**DOCUMENT 00 90 00  
ADDENDUM**

**ADDENDUM NO. [2]                      Date: February 20, 2018**

**RE:                      MEDFORD AREA PUBLIC SCHOOL DISTRICT  
                             ATHLETIC COMPLEX IMPROVEMENTS  
                             1015 WEST BROADWAY  
                             MEDFORD, WISCONSIN 54451  
                             HSR PROJECT NO. 17067**

**C106R1**

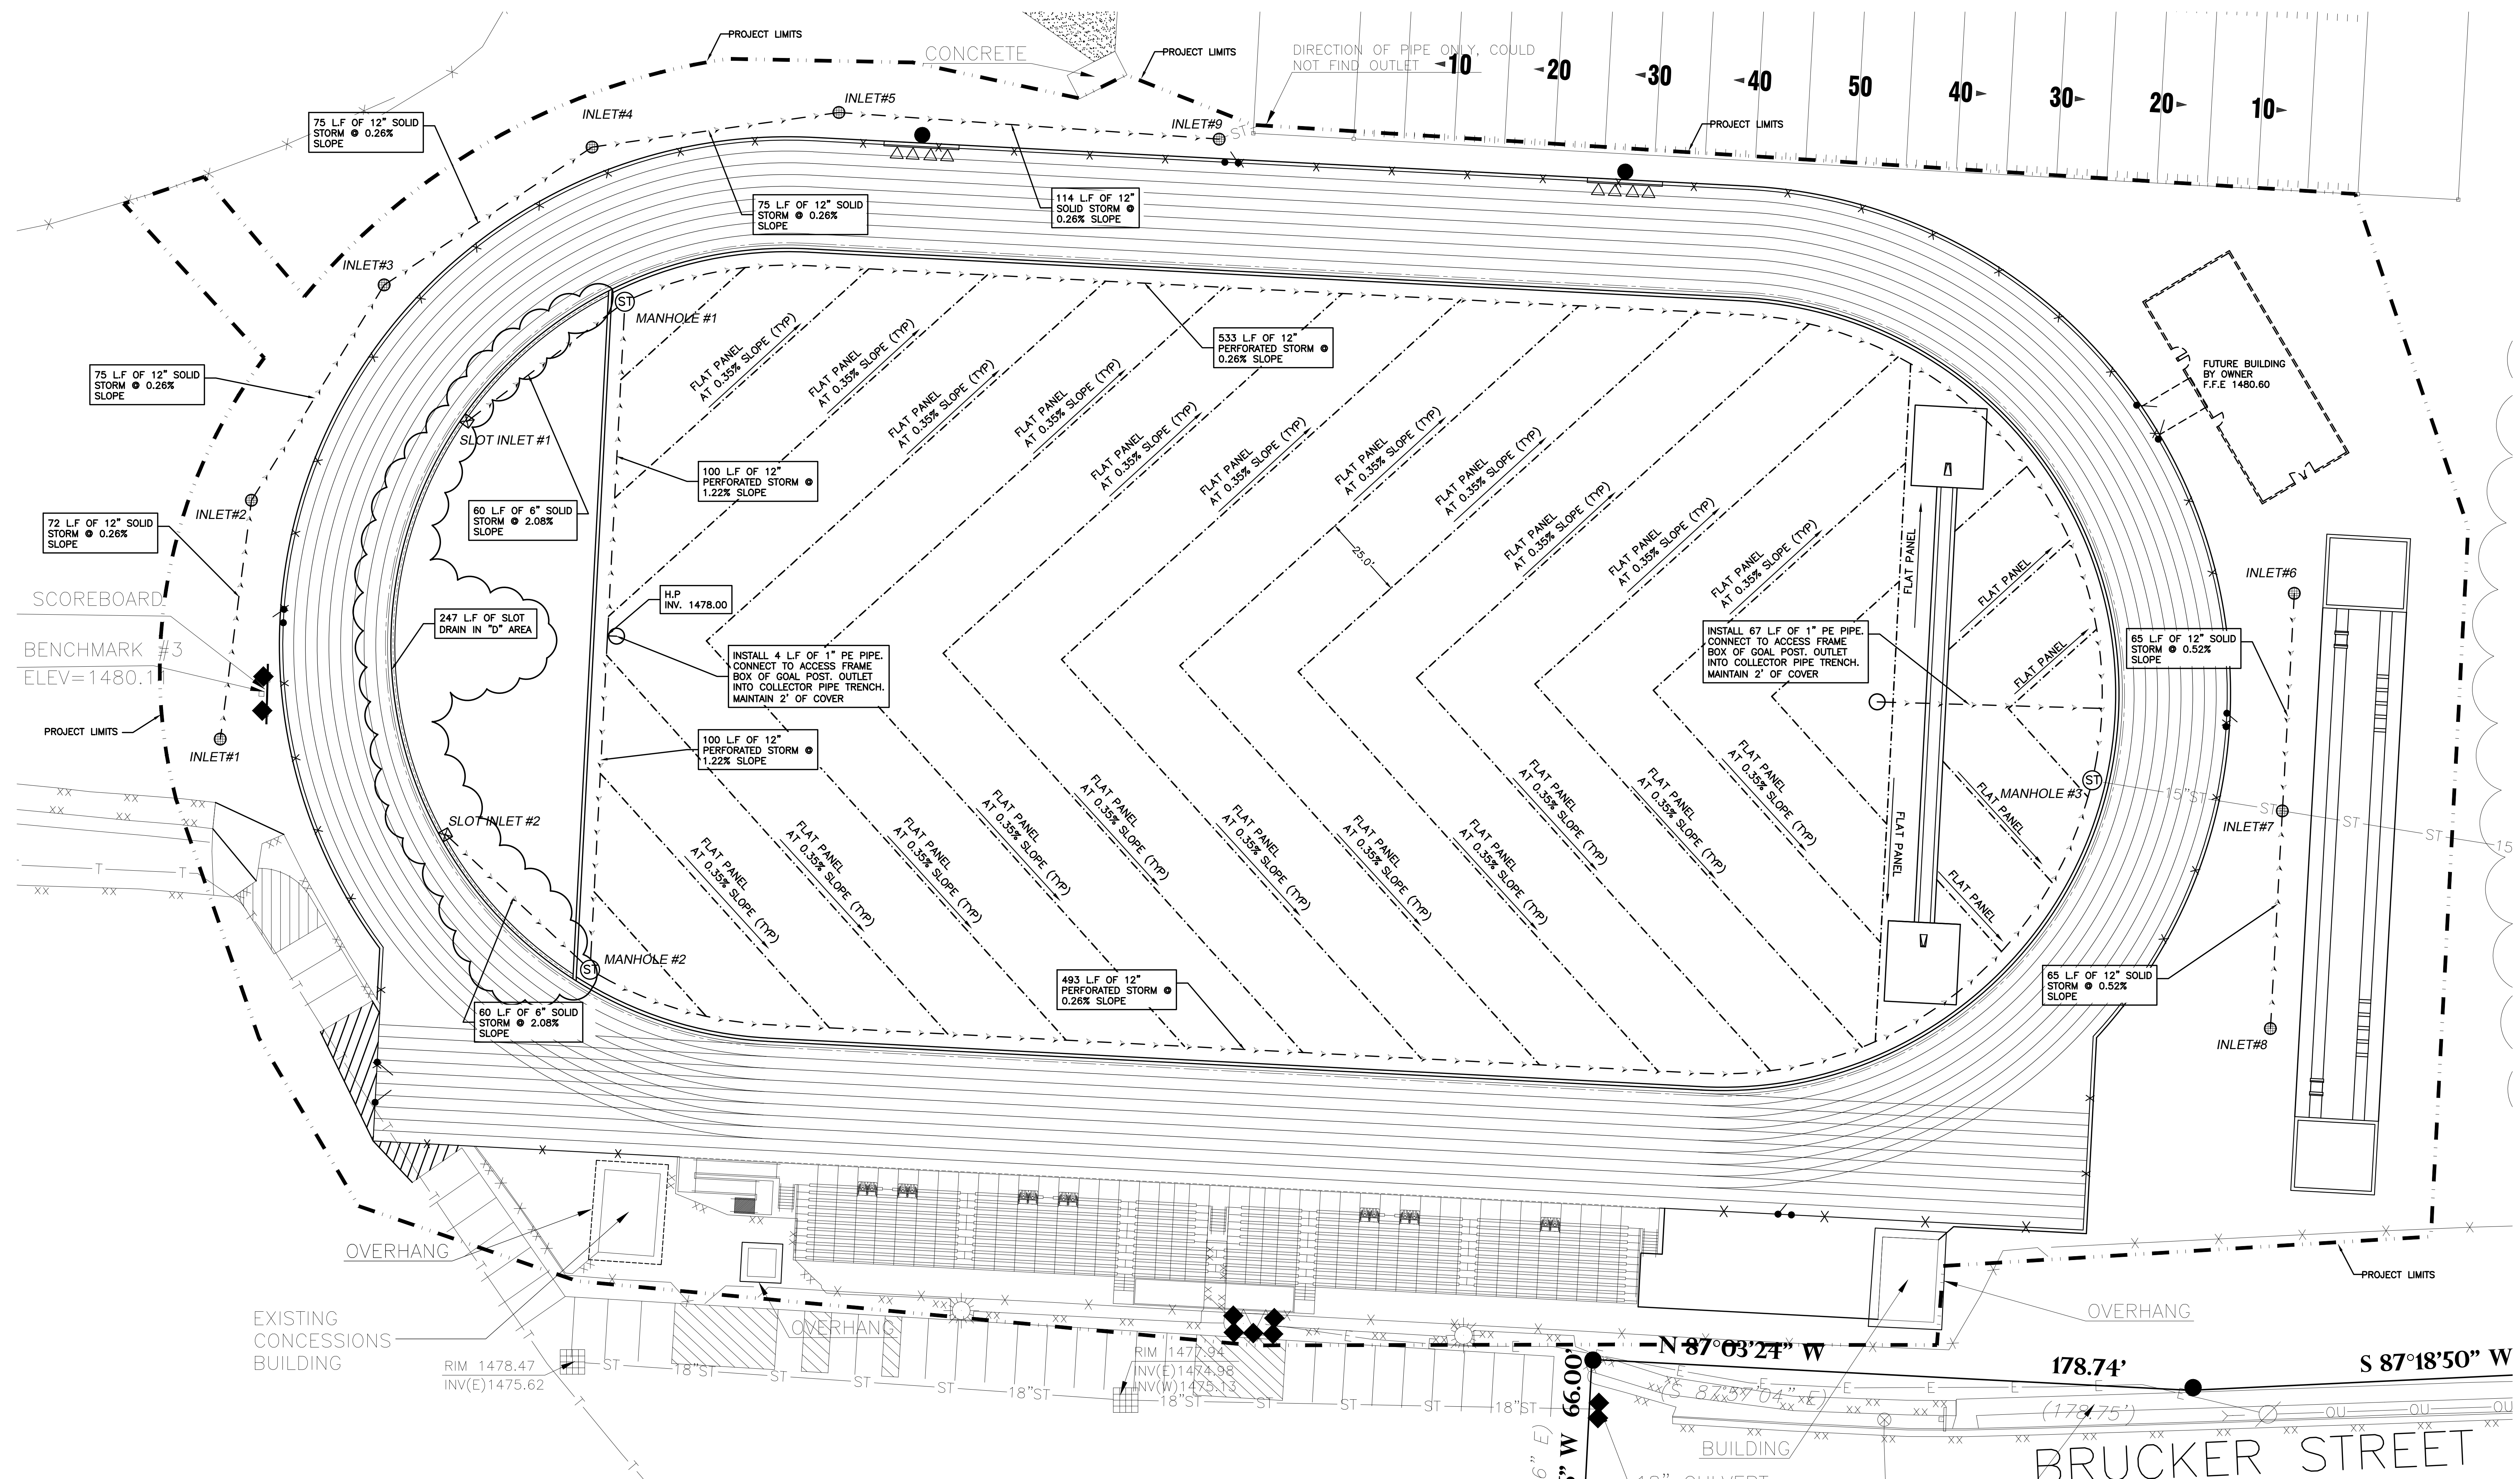
1. Sheet C106R1: SITE STORM SEWER PLAN 30 x 42 attached hereto
  - a. 247LF of slot drain shall be installed in West "D" area.
2. Sheet C109R: SITE DETAILS 30 x 42 attached hereto
  - a. Modify Detail-1. Install additional base drainage stone up to interior 12" concrete curb edge.
